# Safety Evaluation Report

## Related to the License Renewal of the Virgil C. Summer Nuclear Station

Docket No. 50-395

South Carolina Electric & Gas Company

**Figure 1: Wear Degradation of Components in the Extraction Steam System: Theory vs. Actual**

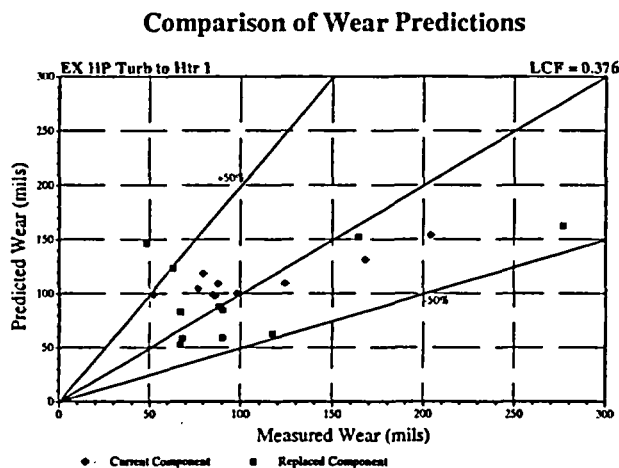
In subsequent correspondence dated September 2, 2003, the applicant discussed the integration of prediction and inspection inherent in its FAC program. The applicant stated the system most susceptible to FAC at VCSNS is the extraction steam system. This conclusion has been confirmed by the applicant's predictive model and the as-found ultrasonic data for many components. The predictive model of record (CHECWORKS™) represents an analysis tool used by the applicant in the selection of problem areas. This model also aids in the inspection scheduling process. Over time, the applicant determined that model predictions with as-found ultrasonic data have returned reasonable agreement. The applicant provided an example of the predicted vs. measured wear comparisons for components in the extraction steam system summarized below.
